SHIP NR. 73. STERNFRAME AND RUDDER

BYGONING NR. 73.
FOR K. ASTERSTEVN

Rudder Stemframe.

Nakskov. No 73

Recommended Arrangement at Heel of Stern Frame

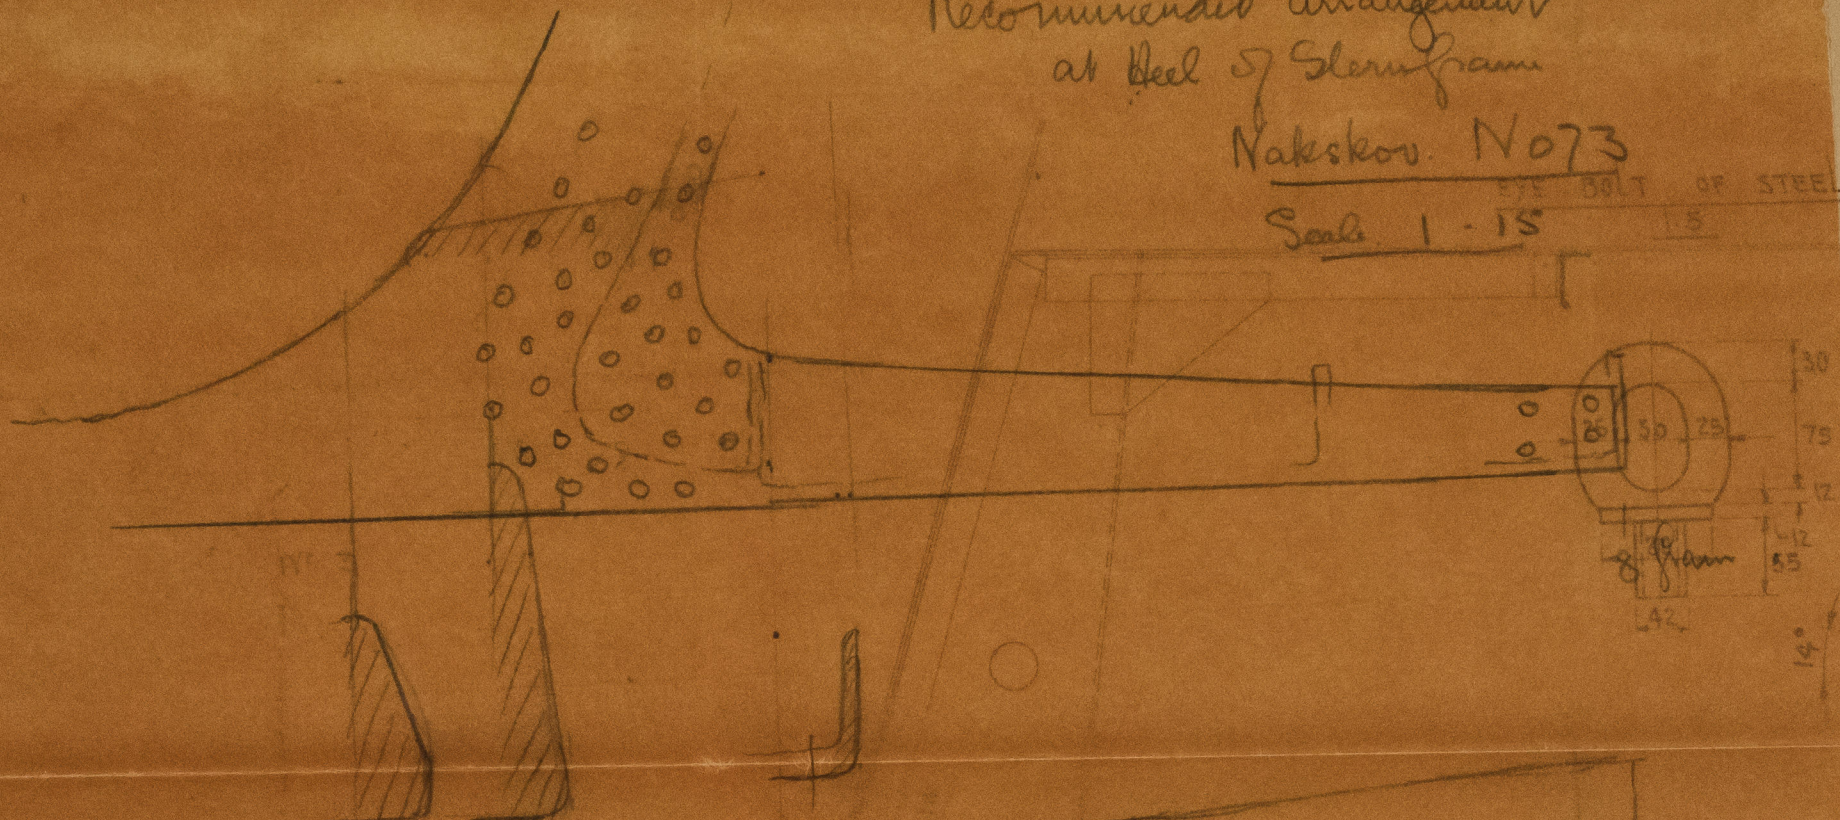
Particulars of Steering Arrangements to be submitted
See Set 200 Plan 9
- Bel 66 Plan 7
